**Technical Service
Information Bulletin**

TRUNK CLOSER MISOPERATION
Models: '01 LS 430

ELECTRICAL
EL004-01

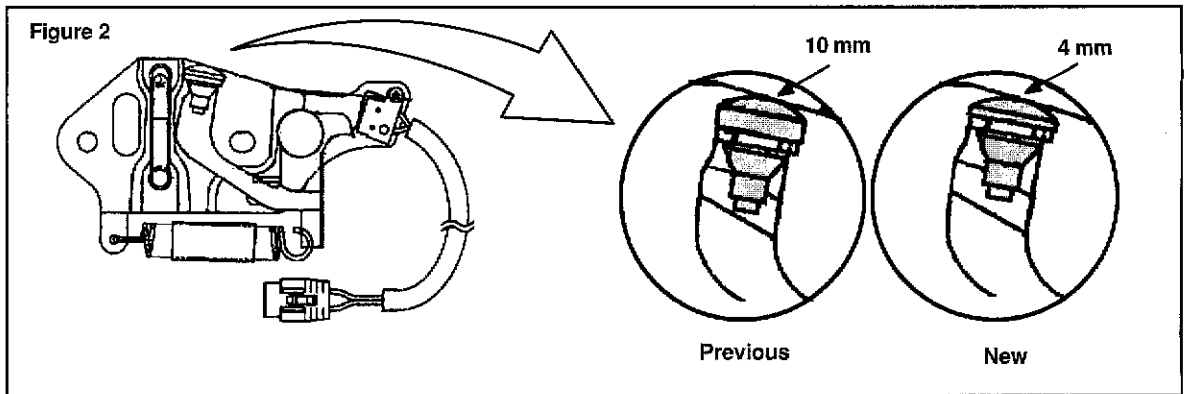
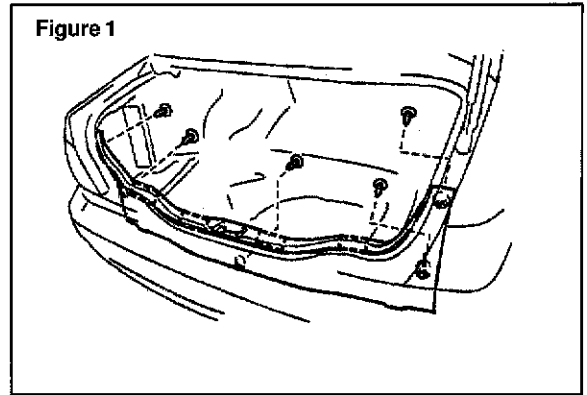
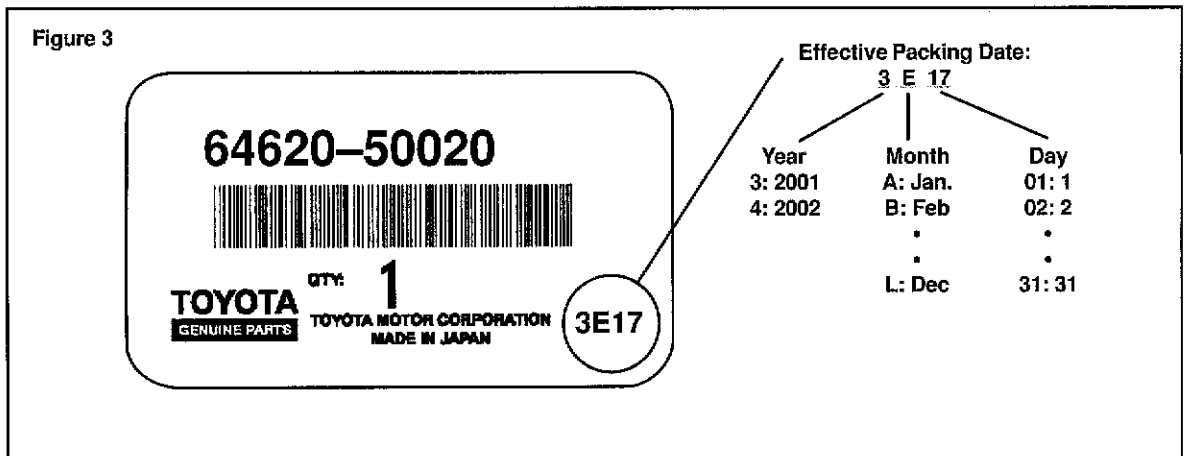
To correct this condition, the following improvements have been made to the hop-up lever of the Luggage Door Striker:

- Rubber height has been decreased.
- Rubber hardness has been increased.

1. Remove the 5 clips securing the rear floor finish plate and remove the panel (see Figure 1).
2. Remove the 2 bolts retaining the luggage door striker.
3. Replace the luggage door striker with an updated part (as identified on the parts label). (See Figures 2 and 3.)

3 E 17 or later production parts have been updated.
